**CHARTER TOWNSHIP OF GARFIELD
PLANNING COMMISSION MEETING**

Wednesday, December 11, 2024 at 7:00 pm
Garfield Township Hall
3848 Veterans Drive
Traverse City, MI 49684
Ph: (231) 941-1620

A G E N D A

SITE PLAN

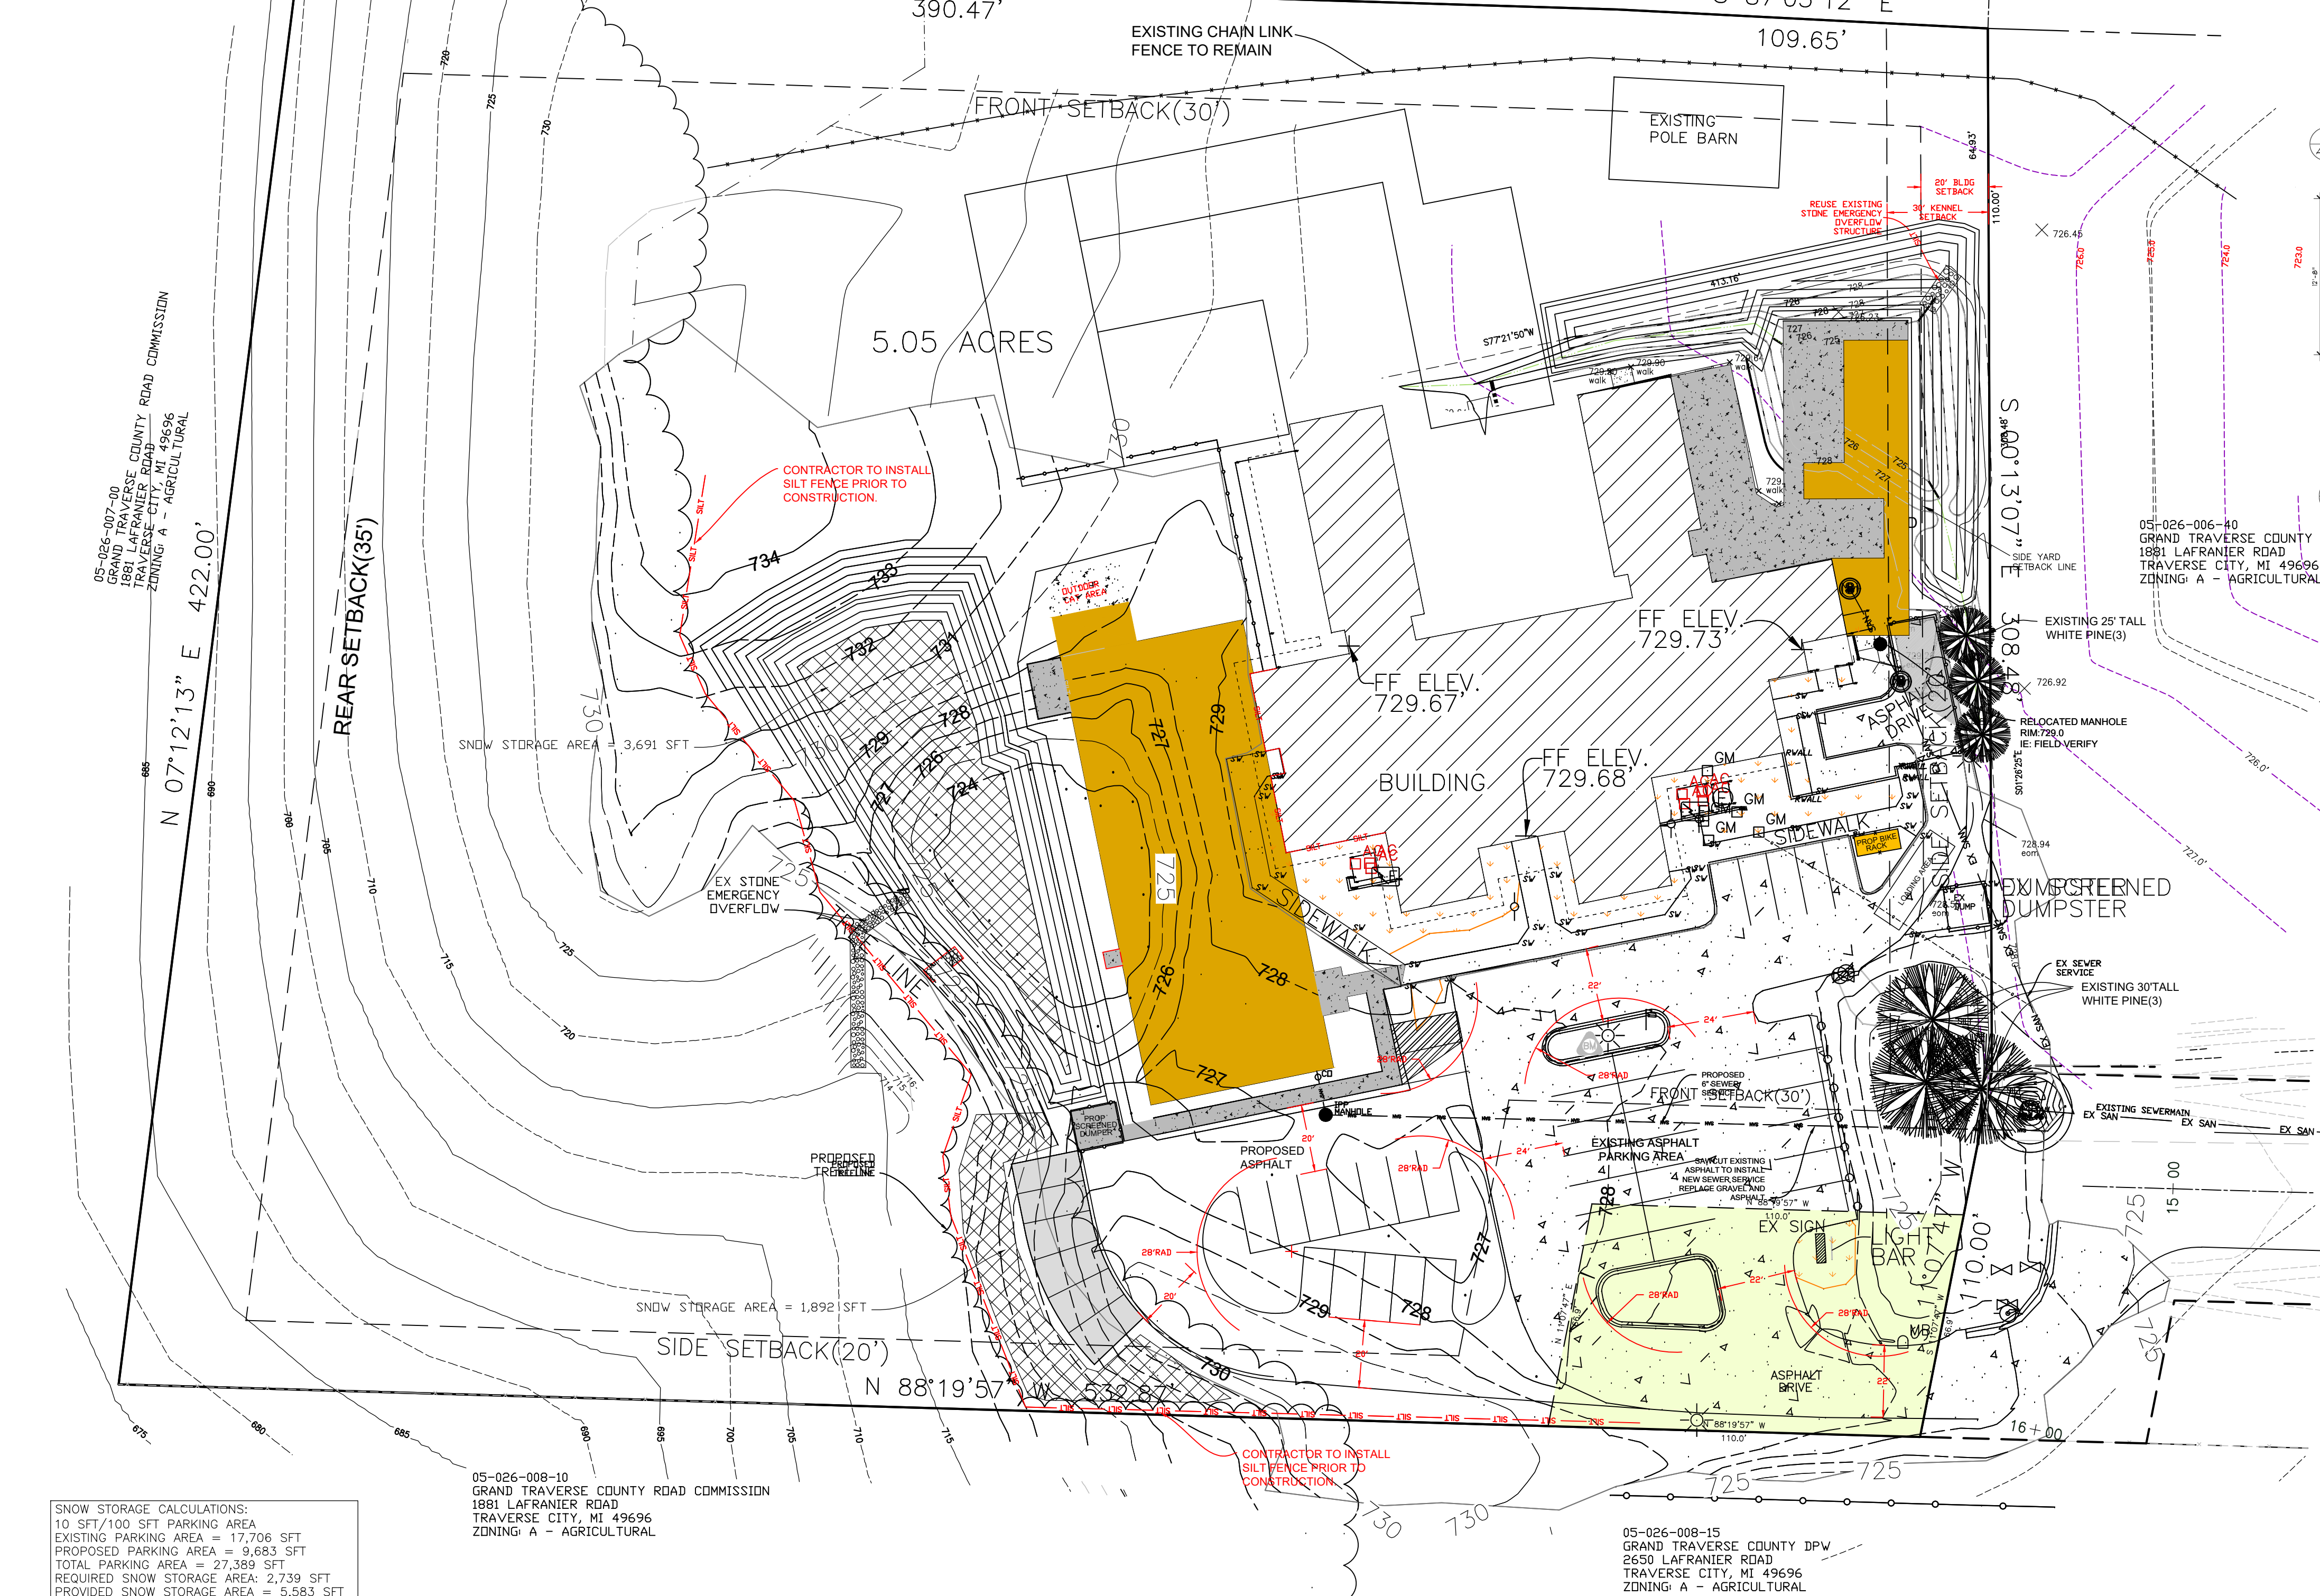
According to the updated site plan, the scope of work consists of two (2) building additions totaling 9,256 square feet to an existing 14,071 square-foot building. The south lot line is considered the front yard based on the easement provided as described above. The east lot line is considered a side yard. The updated site plan set, including Sheet C-1, has been corrected so that the entire building falls within the side yard setback.

LANDSCAPING PLAN

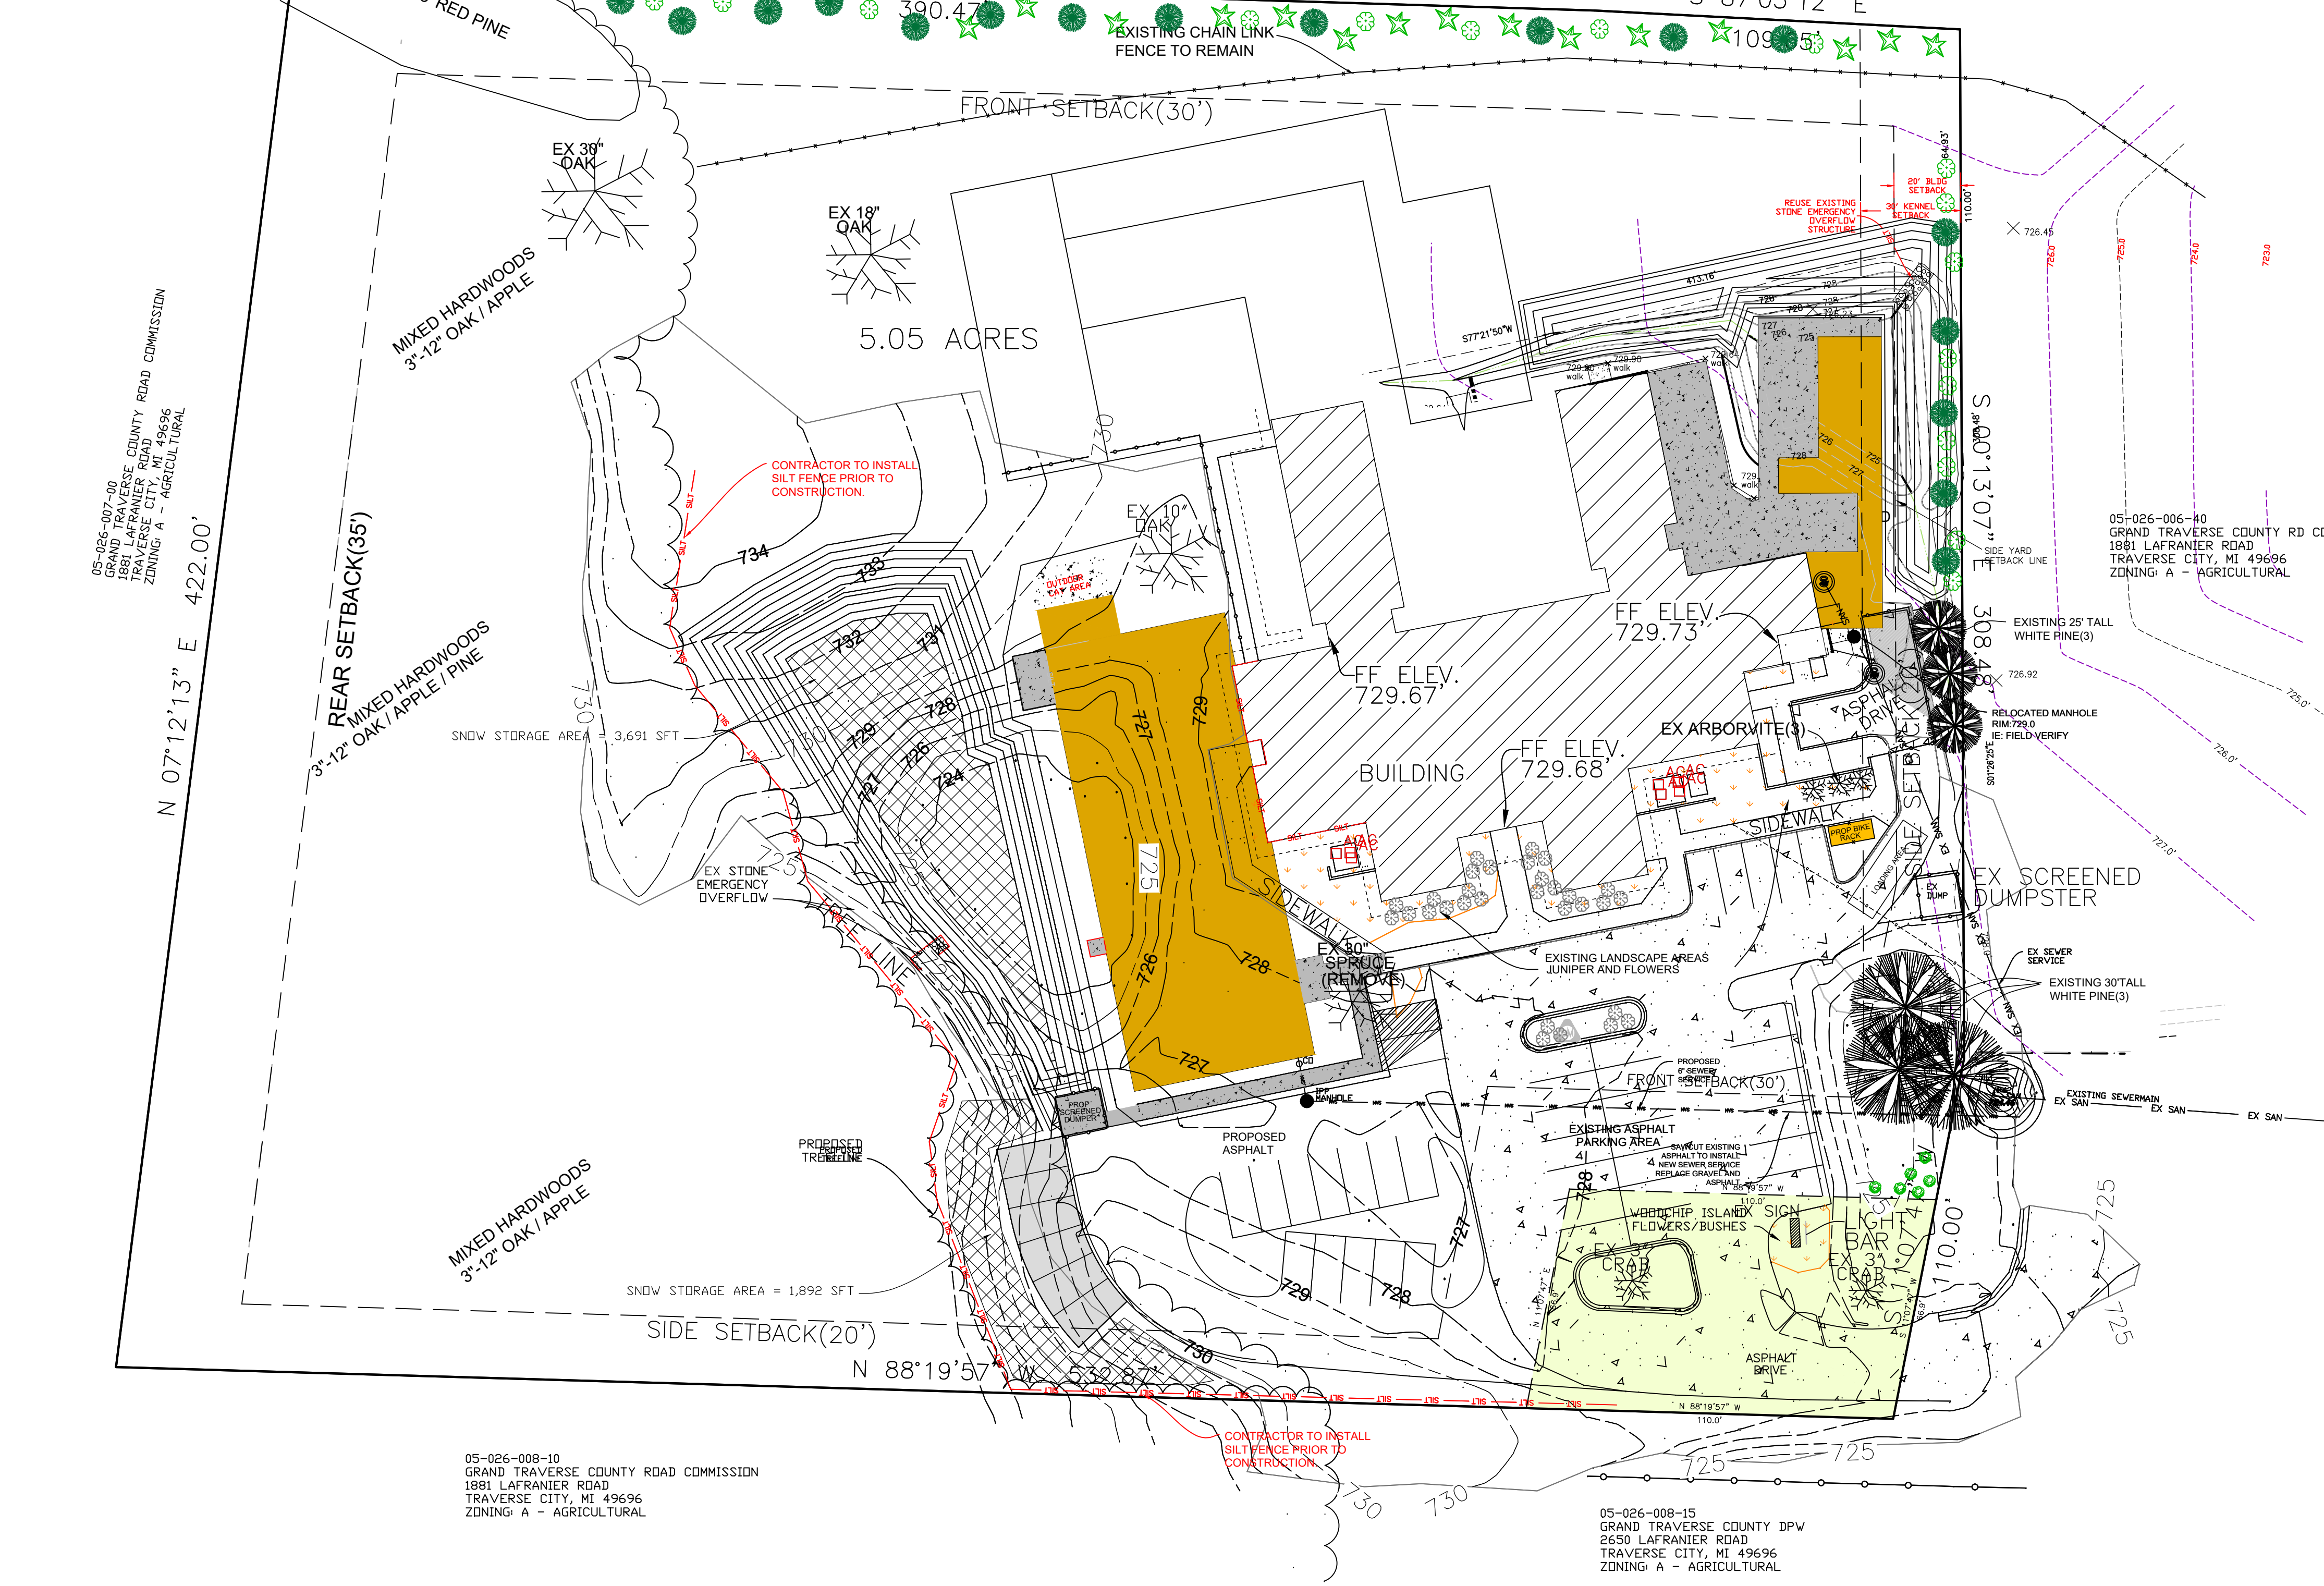
- 3. The landscape plan needs to include details of any existing landscaping intended for the landscaping requirements, especially the six (6) trees on the east lot line, to determine the appropriate credit based on Table 530.L.*

- 4. The landscaping plan needs to be updated to identify the correct required buffer.*
- 5. Any new landscaping material on the east lot line should not be placed in the easement area for the extension of Ahlberg Drive.*

- 6. The landscape plan needs to be updated to reflect its correct scale.*
- 7. The traffic generation for the remainder of the building area needs to be accounted for and additional parking may need to be provided.*

PER SECTION/TABLE 530.L LANDSCAPING CREDIT, EXISTING PINE TREES ALONG EAST PROPERTY LINE ALL ARE GREATER THAN 16" TALL WHICH ALLOWS FOR 1.4 CREDIT. THEREFORE PROPOSAL TO TRANSFER CREDIT AND REPLACE CREDIT FOR FOUR(4) CANOPY TREES.
